ADDENDUM 2

COLONIAL HEIGHTS HIGH SCHOOL RENOVATION/ADDITION COLONIAL HEIGHTS, VIRGINIA

VIRGINIA DOE PROJECT NUMBER: 2022-8000-2

ADDENDUM NO. 2 / July 29, 2022

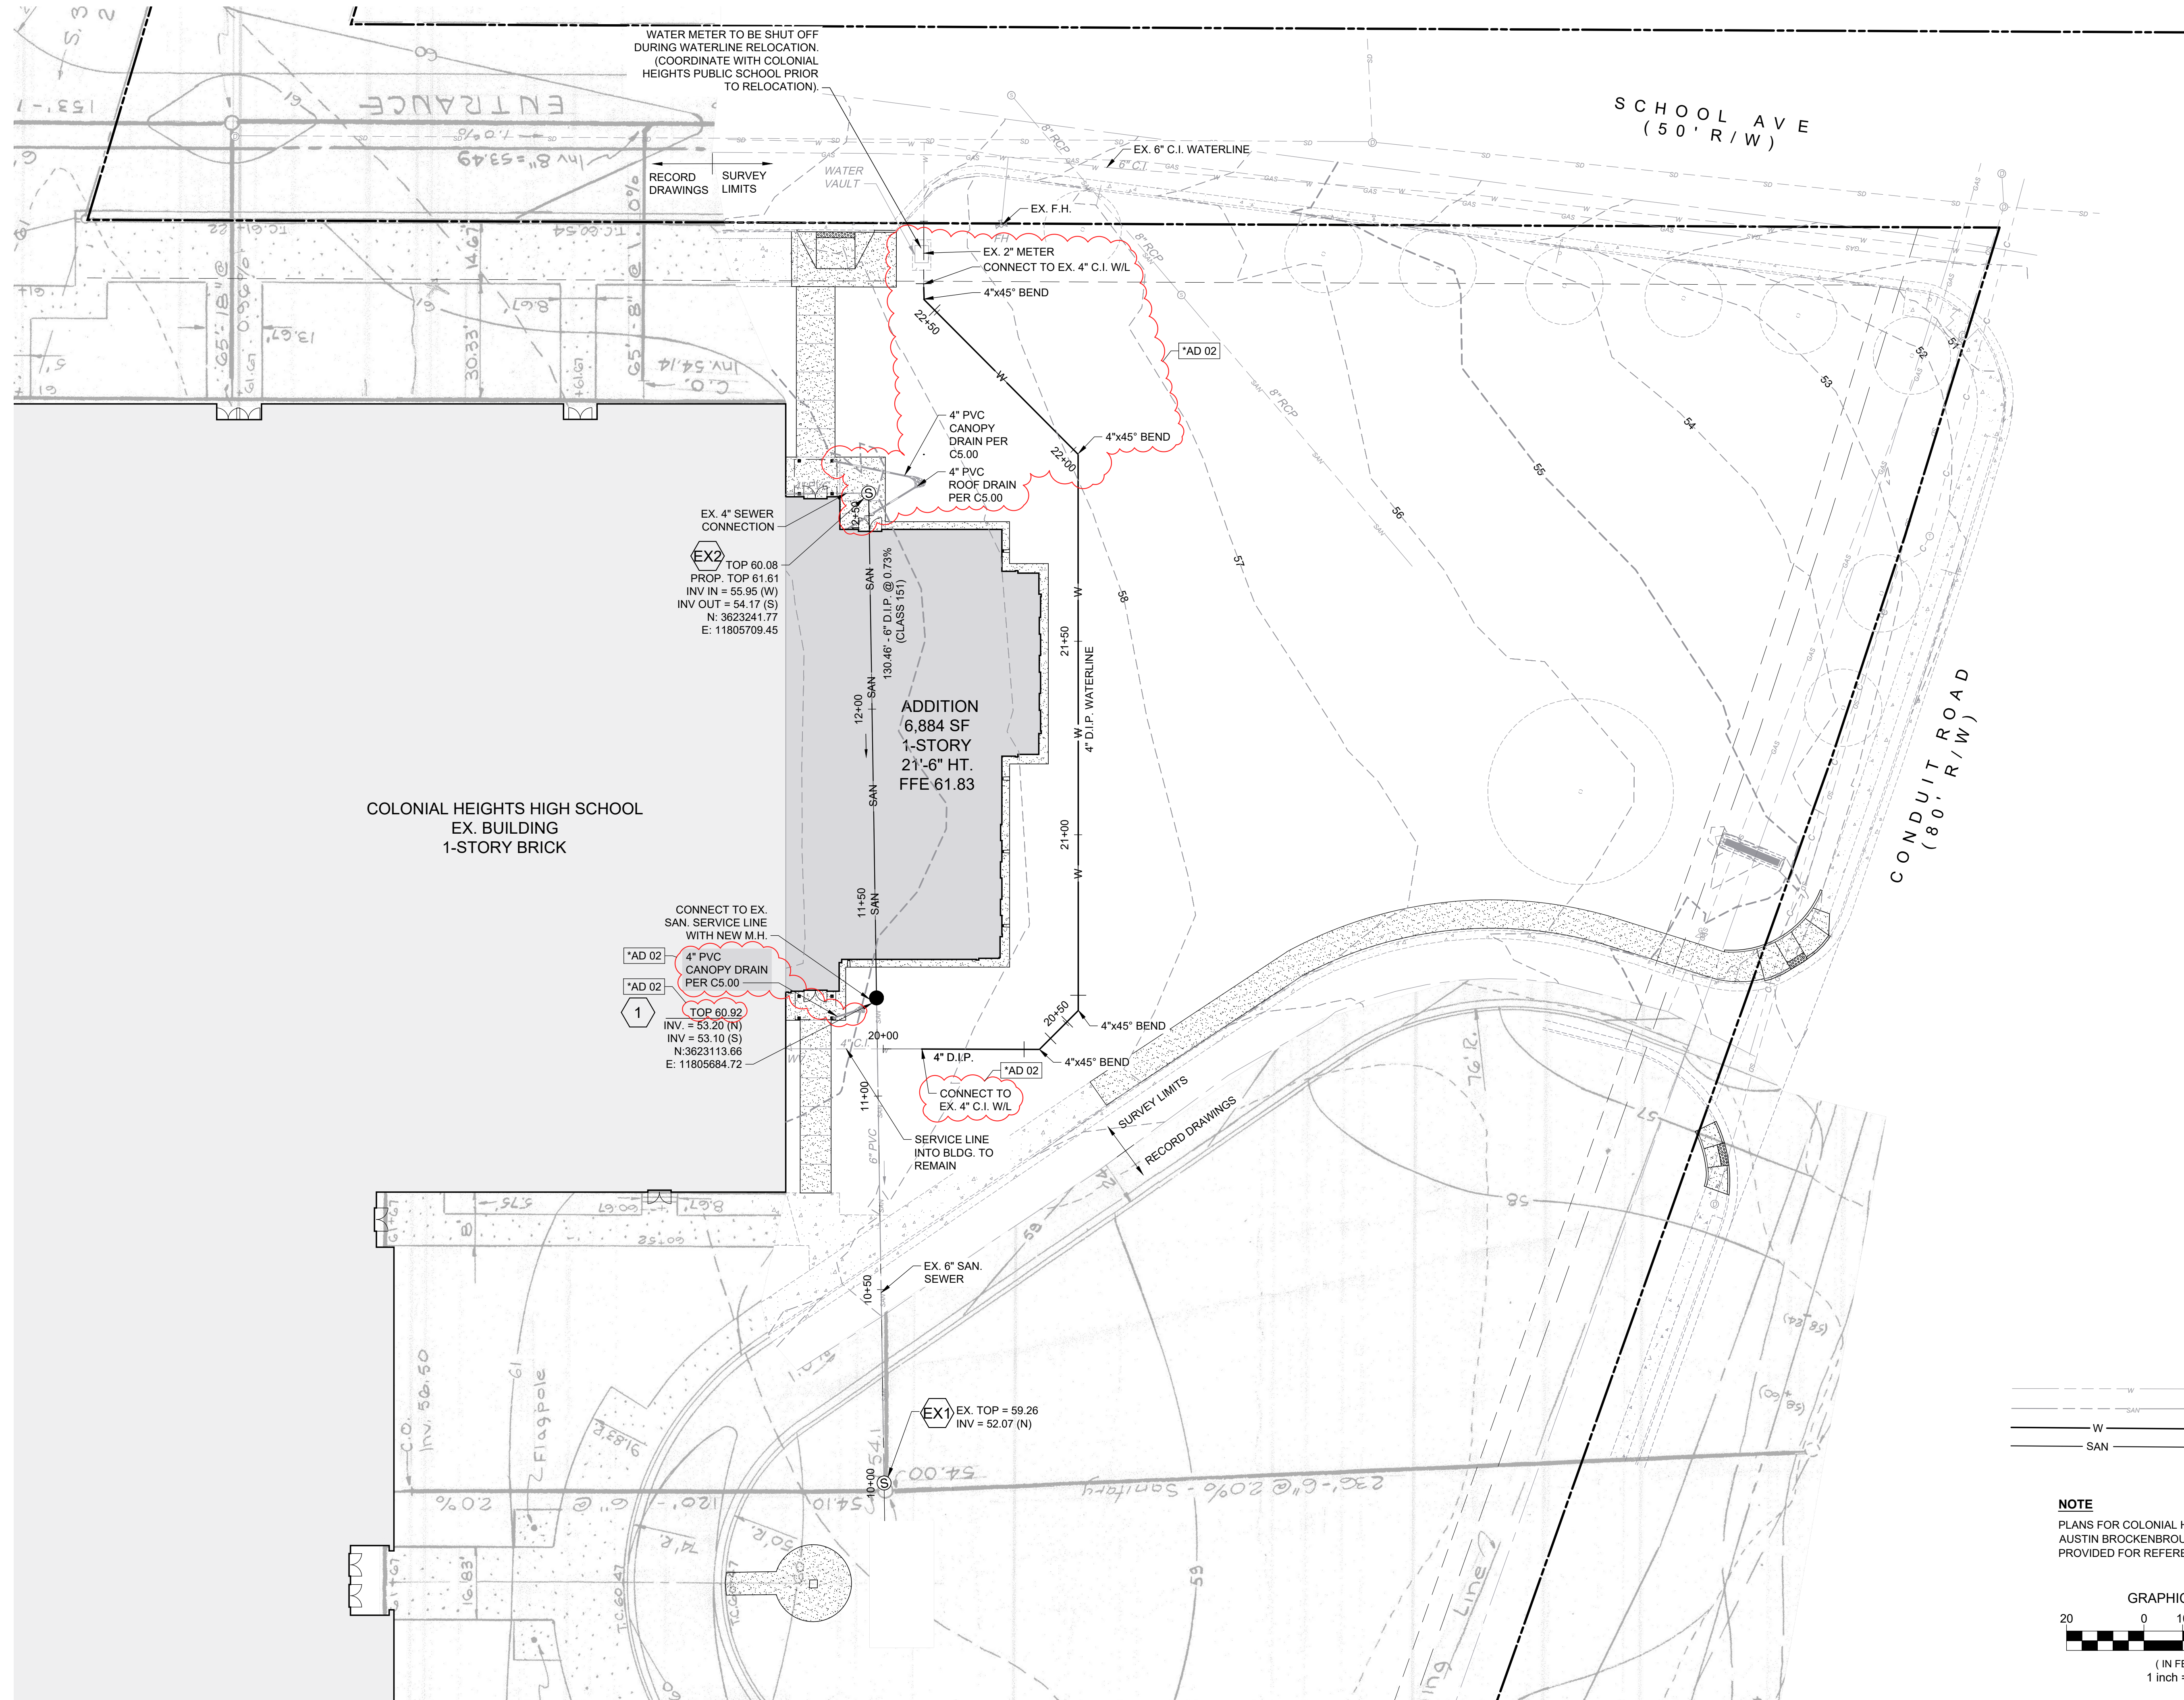
Answer: Yes the Owner will remove those items. Not in contractor scope.
8. Drawing A1.0.1 Architectural Site Plan. Details 2 and 3 for the new post supported canopies indicate internal gutter and downspout system with storm water to be collected below grade and to see civils for extents. C5.00 Grading & Drainage plan does not pick up the canopy drainage but

does show roof drainage through gutters and downspouts splashing on the ground with overland flow across the site. Please provide plan for canopy stormwater drainage.

Answer: See Addendum 2 sheet C4.00 (AD 02) for clarification.
